Re: Recall - Shasta Industries - 5th Wheel Travel Trailer Frames

99V-228 (01)

Date: February 25, 2000
To: All Shasta Authorized Dealers
From: Joe Kell, Customer Service/Warranty Manager
RE: Recall #99V228
Priority:

PROCEDURE FOR CROSS-MEMBER INSTALLATION :

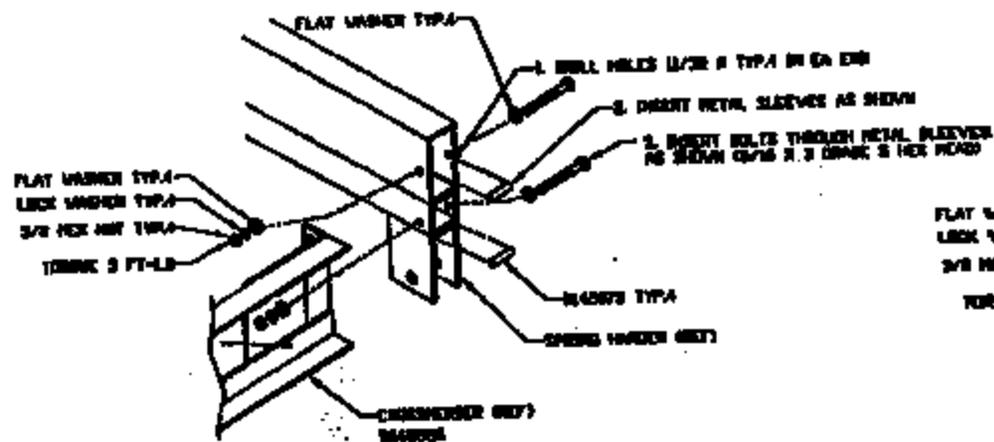
1. Inspect the frame. If the unit has rod and angle cross members (as shown in drawing #F1X2000) the recall is not needed. You may claim .2 for the inspection using Operation Code #1190V.

3. If the unit has no cross members as in Step 1, and the main frame rails ARE I-Beams, then the I-Beam must be inspected for cracks. Cracks may exist in the I-Beam above and between the spring hangers. Carefully inspect both I-Beams thoroughly. If there are no cracks, skip to Step 5.

4. If there are cracks, weld them shut and plate over repaired area on the outside of the I-Beam using 1/4" flat steel. The steel can be purchased locally. It should be cut so that it fits snugly against the top and bottom flange. The welds should be made in the corner created by the intersection of the web and flange. Then paint. All four corners should be supported and the ground wire removed before welding. You may claim .5 per I-Beam using Operation Code #1190V.

5. If there are no cracks, install the cross members (available through our Parts Department) following the attached instructions titled "Procedure for Cross-Member Installation". You may claim 1.0 per cross member using Operation Code 1190V.

DETAIL 'B'

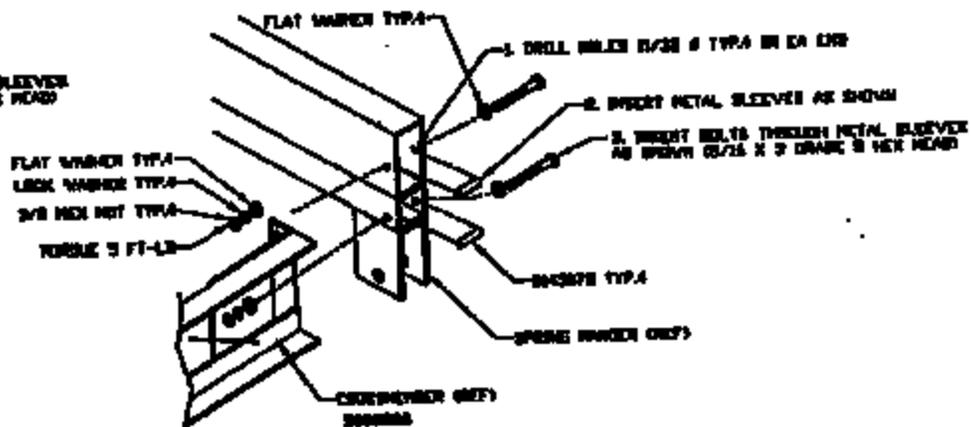
- 5) **PLACE THE APPROPRIATE CROSS-MEMBER INTO POSITION AS INDICATED IN DETAIL "B". IT SHOULD BE POSITIONED AND HELD IN PLACE WITH CLAMPS SO THAT HOLE LOCATIONS CAN BE MARKED ON THE FRAME TUBES FOR DRILLING IN STEP 6). IN SOME INSTANCES AN ABS DRAIN LINE WILL NEED TO BE CUT IN ORDER FOR THE CROSS-MEMBER TO BE PLACED INTO POSITION. IF THIS IS REQUIRED, IT IS TO BE RECONNECTED AT THE COMPLETION OF THE CROSS-MEMBER INSTALLATION.**

- 6) **REMOVE THE CROSS-MEMBER SO THAT AN 11/32 DRILL CAN BE USED TO DRILL HOLES THROUGH BOTH SIDES OF THE TUBE AS MARKED IN THE PREVIOUS STEP.**

7) REPOSITION THE CROSS-MEMBER AND BOLT INTO PLACE. IT SHOULD BE NOTED THAT A STEEL SLEEVE IS TO BE INSERTED INTO THE END OF THE TUBE SO THAT THE BOLT PASSES THROUGH IT. THIS WILL PREVENT THE TUBE FROM COLLAPSING WHEN THE NUT IS TIGHTENED.

8) WITH THE BOLTS, STEEL SLEEVES, FLAT WASHERS, LOCK WASHERS, AND NUTS IN PLACE AND THE CROSS-MEMBER INSTALLED IN POSITION THE NUTS SHOULD BE TIGHTENED TO 17 FT-LB.
